July 23, 2024

**RWB CONSULTING ENGINEERS
MECHANICAL, PLUMBING & ELECTRICAL ADDENDUM 2 ITEMS FOR
WALNUT GROVE MIDDLE SCHOOL CHILLER REPLACEMENT
MIDLOTHIAN I.S.D.**

MP1.01

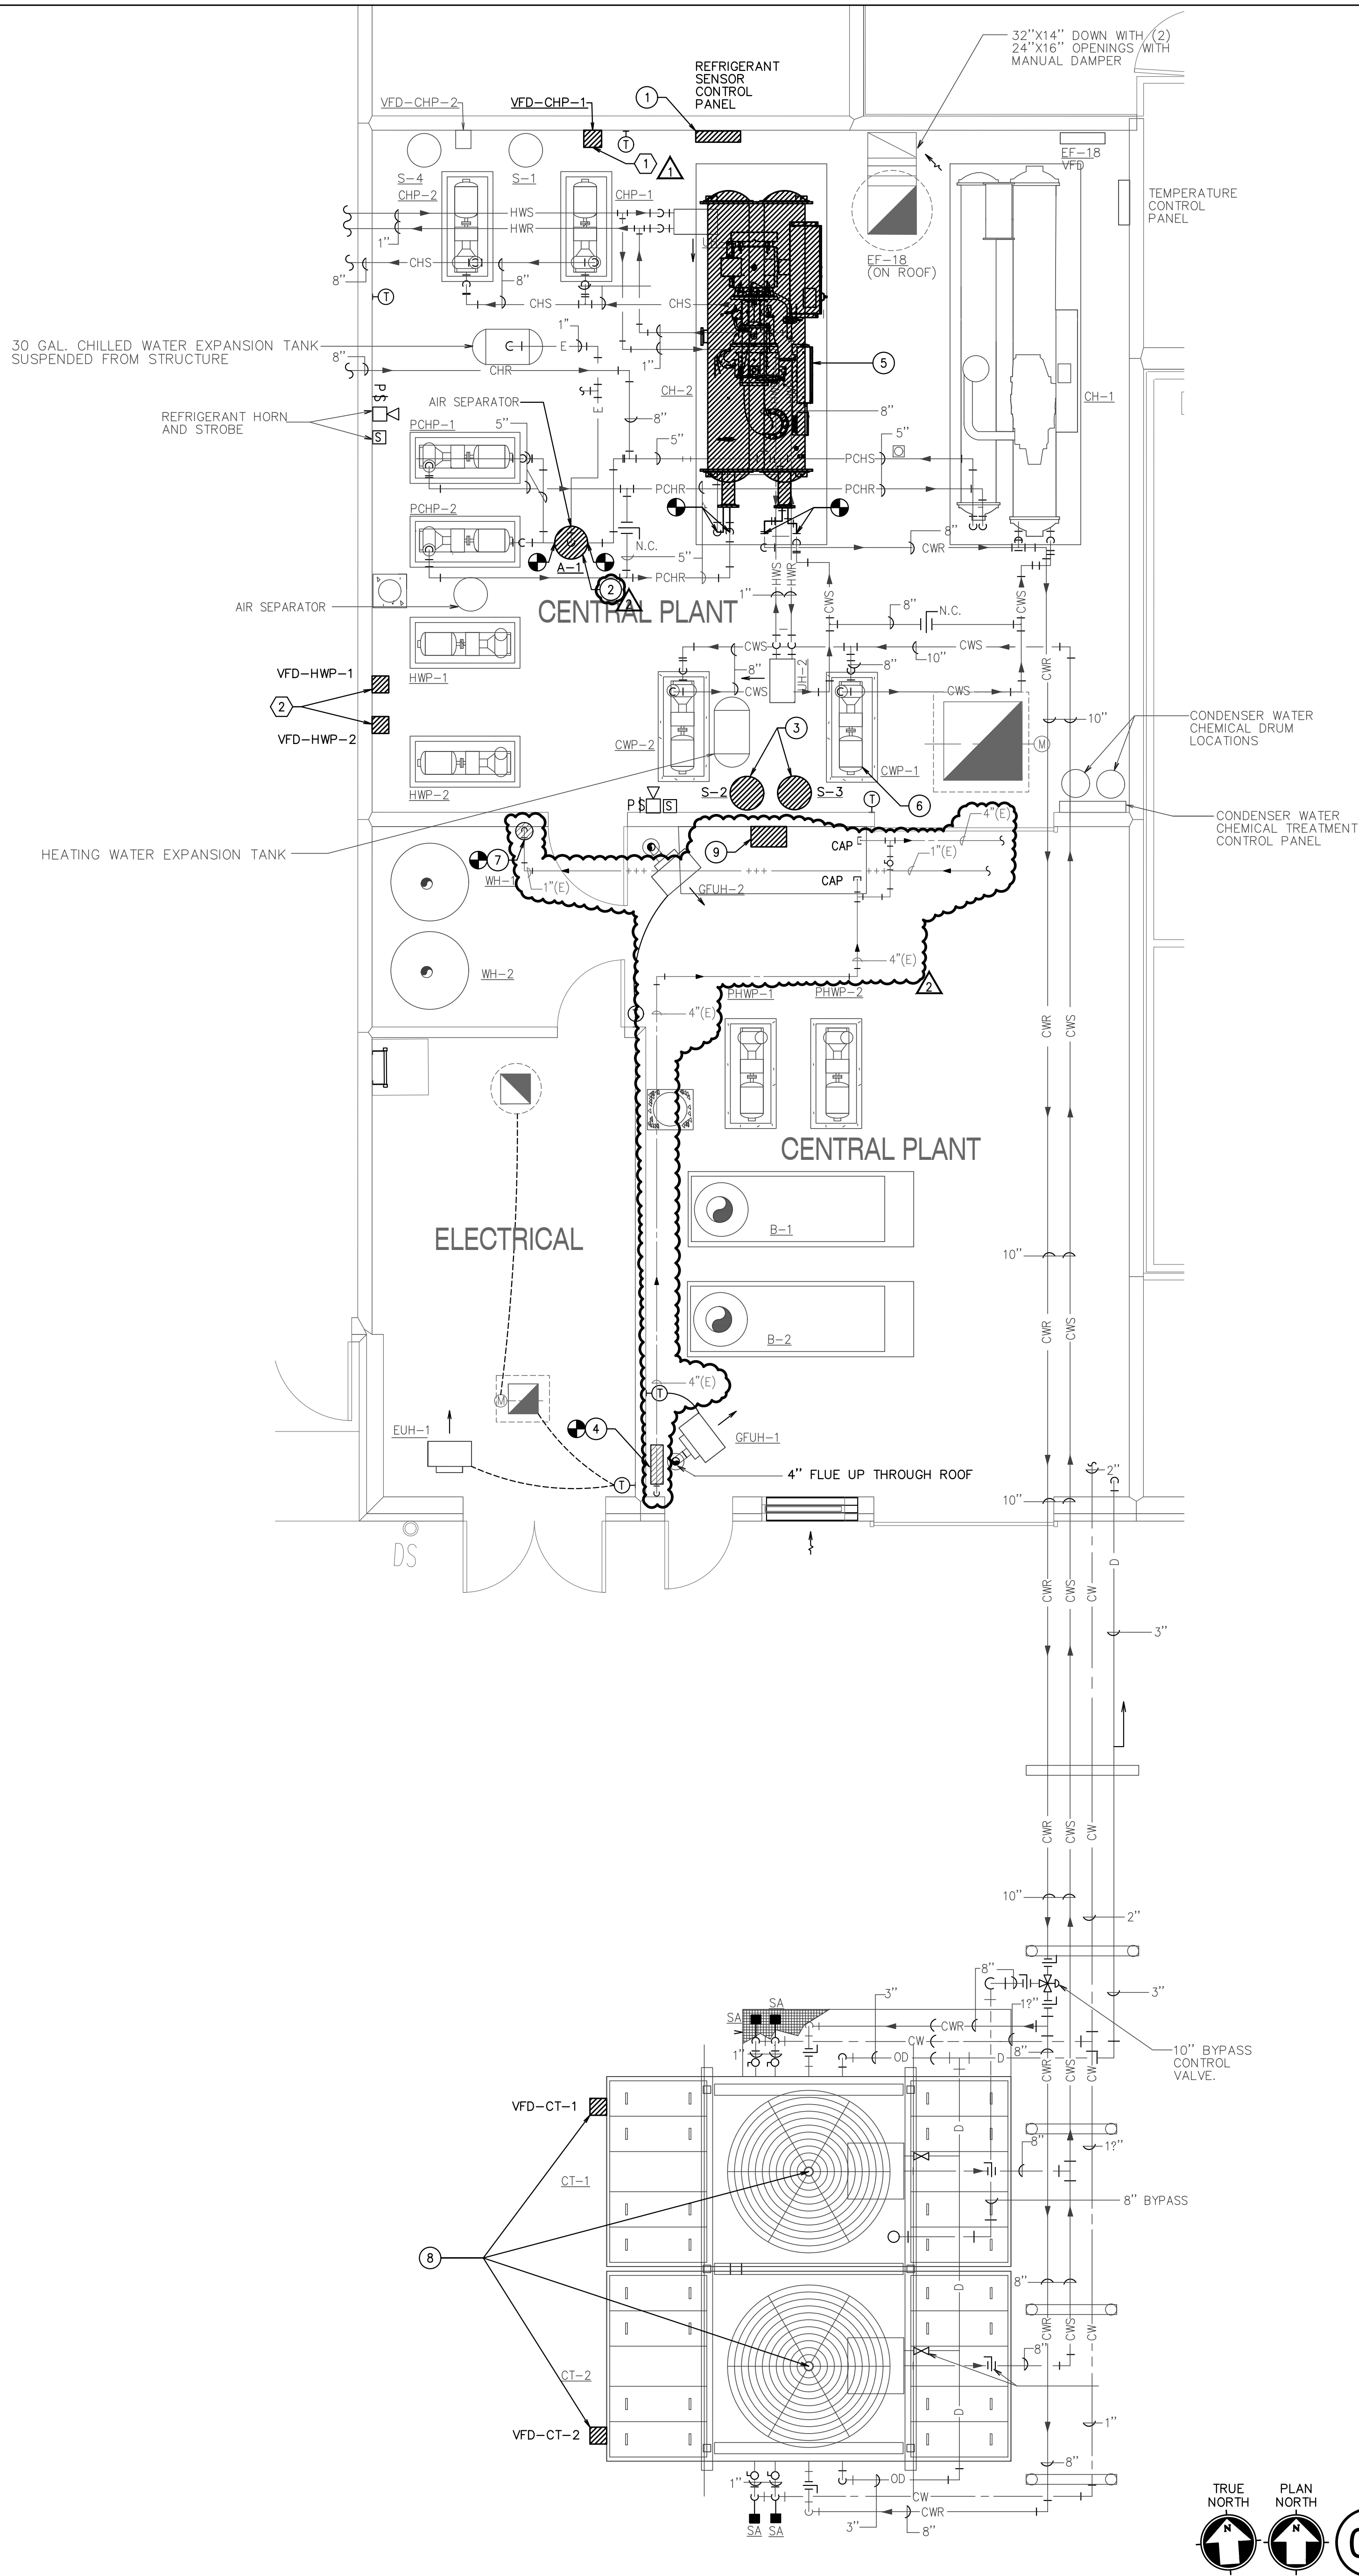
- ii. On drawing MP1.01, should the note at the air separator be Note 2?

- iii. On drawing MP1.01, Note 3 reads "to be installed under alternate scope". This is to be included in the base bid correct?

Response: Yes, it should be note 2. Will correct in the Addendum.

Response: Yes, it should be part of base bid. Will correct it in the Addendum.

- 2 NEW AIR SEPARATOR TO BE INSTALLED. RE-CONNECT EXISTING DRAIN LINE, MAKE-UP/EXPANSION WATER LINE AND PROVIDE NEW UNIONS AND PIPING IN MAIN CHILLED-WATER LINE AS NEEDED.
